Permit Application Review

Permit No. 2020-13
Received complete: February 11, 2020

Project: U-Haul Storage Rental Redevelopment

Location: 8901 Lyndale Avenue South: Bloomington

C3-10

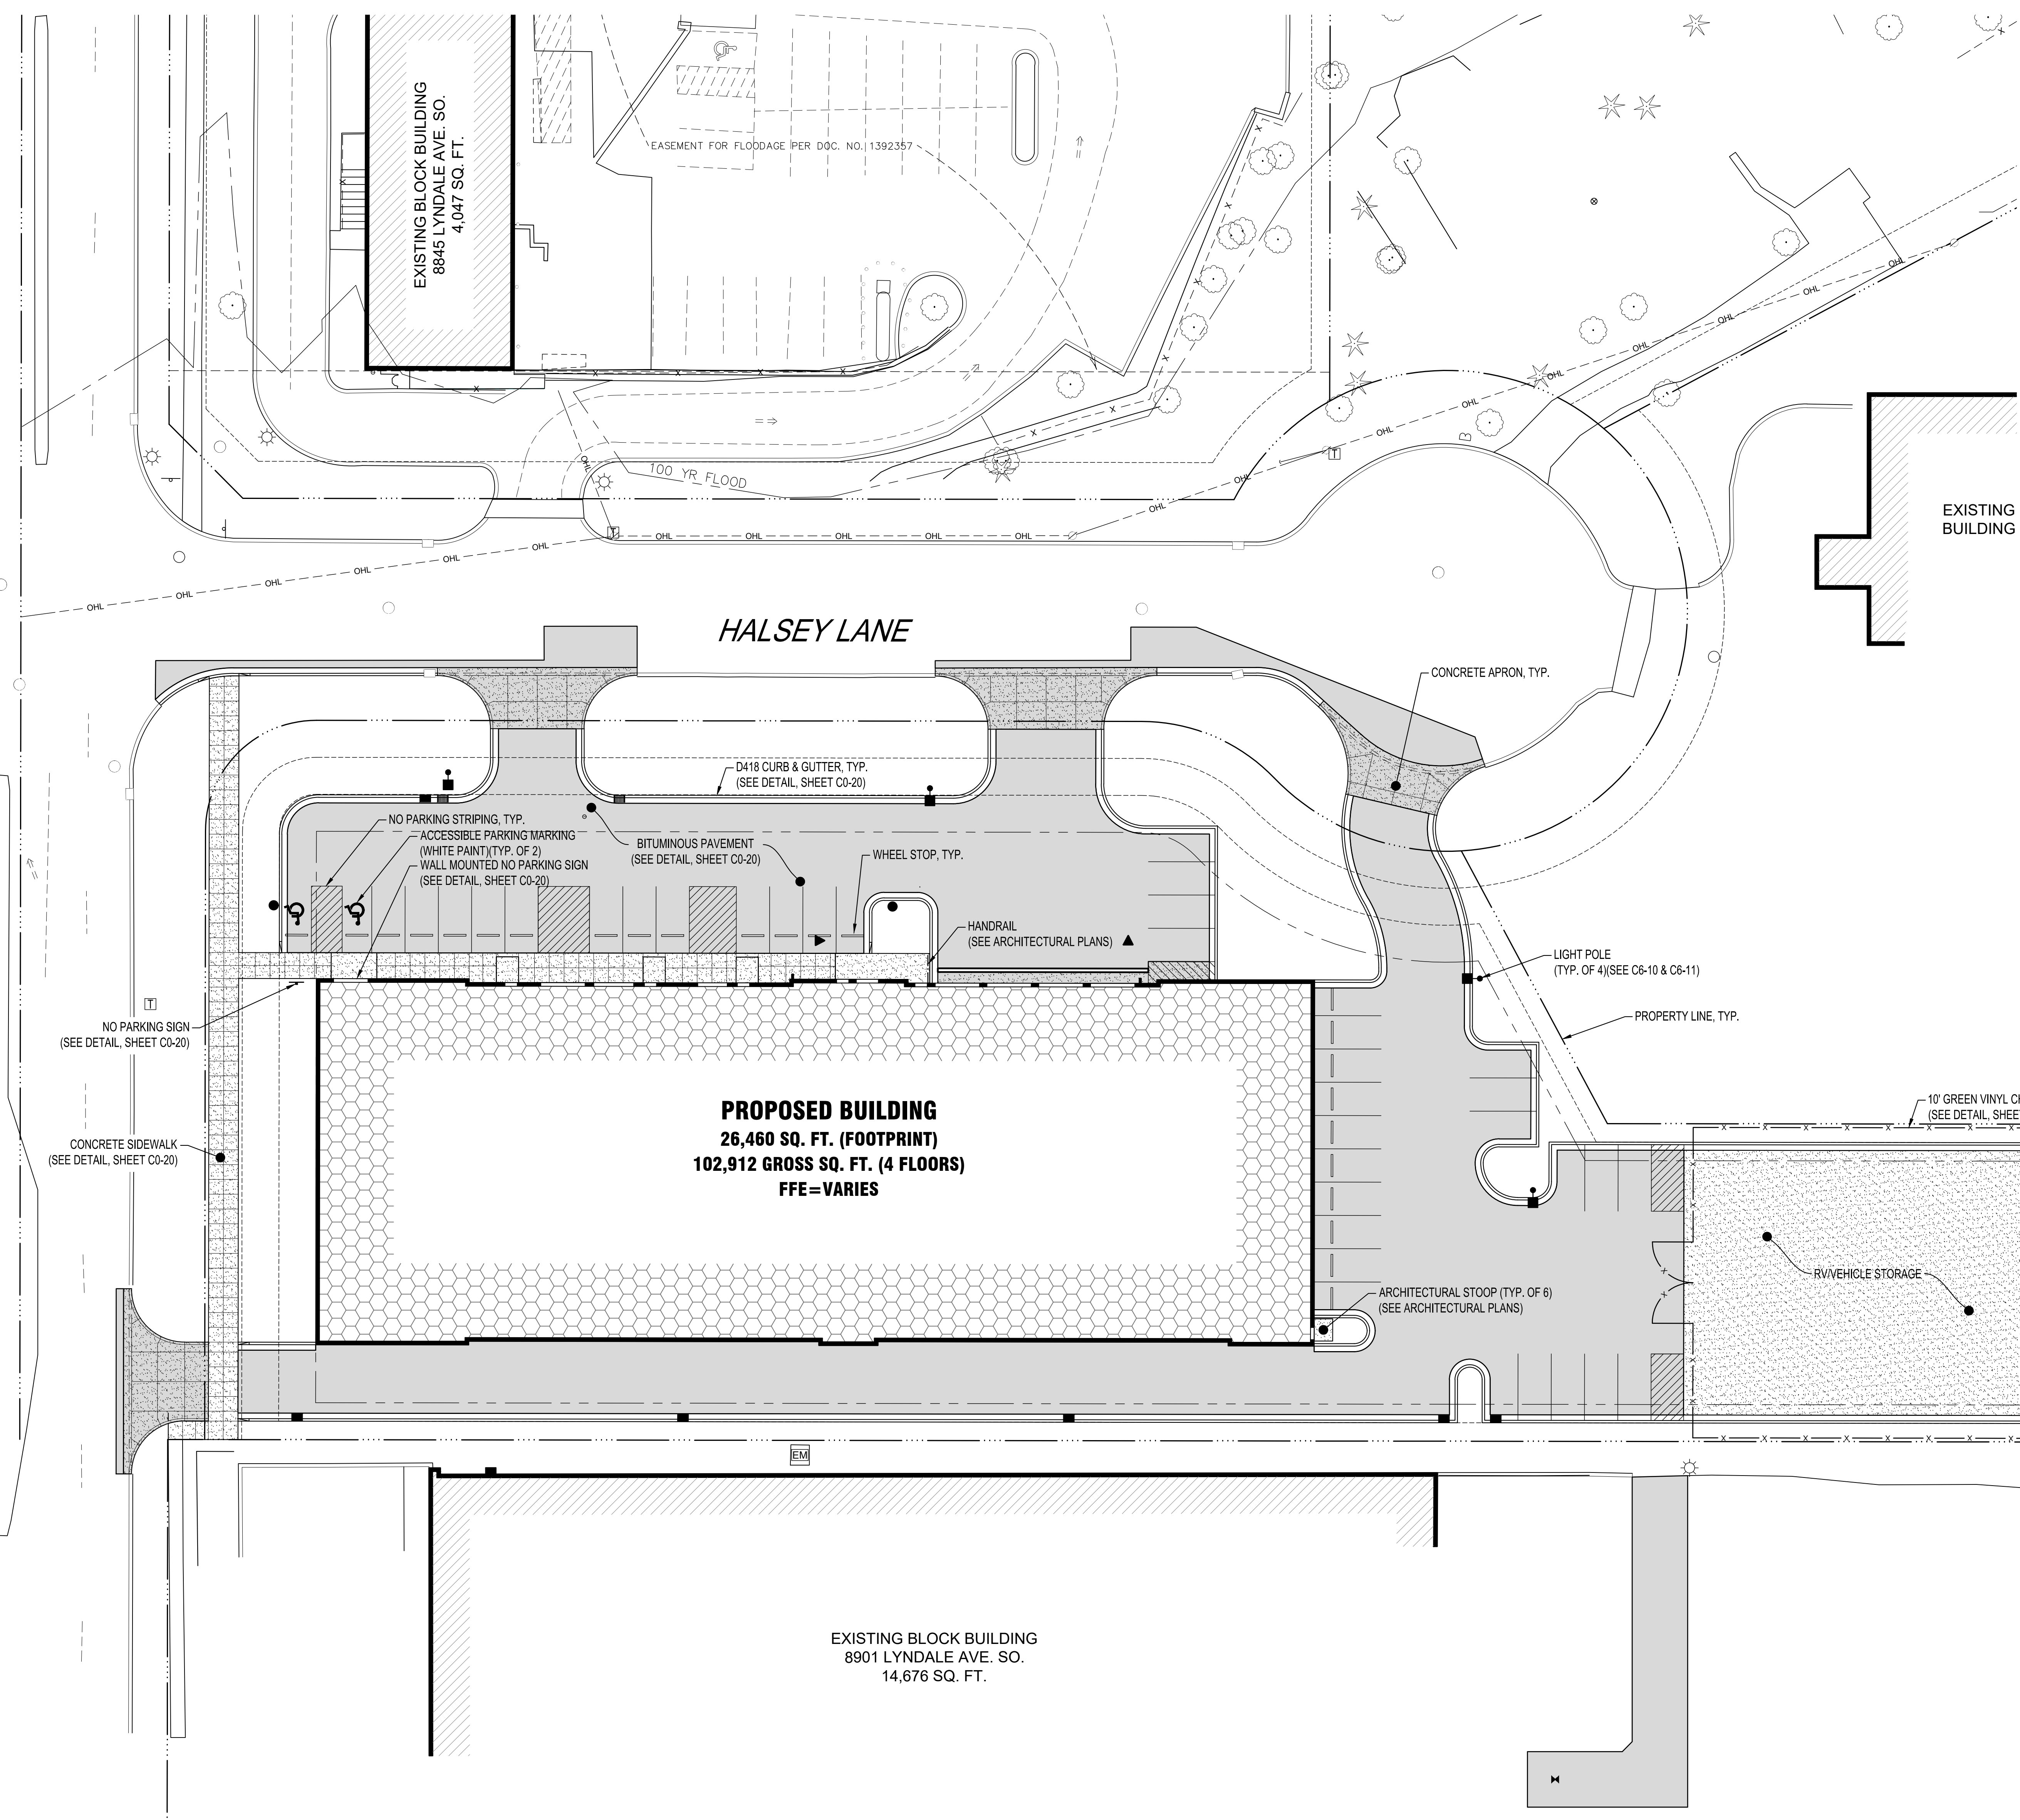
6. Submittal of a plan with the design detail for the underground infiltration system outlet control structure on the plans. A detail of the outlet control structure is required prior to issuance of the permit.

7. Submittal of a revised plan showing identification of the following on the plans:
 - a. The 100-year high water elevation for the proposed infiltration system (Rule 4.5.3.c).

- b. The proposed building low floor elevation (identified at an elevation of 828 feet in the Stormwater Management Report).
 - c. The 100-year floodplain, elevation 823.8 M.S.L., located near the northern and northwestern boundary of the site. The plans show matching of existing contours below the floodplain elevation of 823.8 feet M.S.L., where bituminous pavement will be removed and replaced. Therefore, criteria from Rule 2 does not apply.
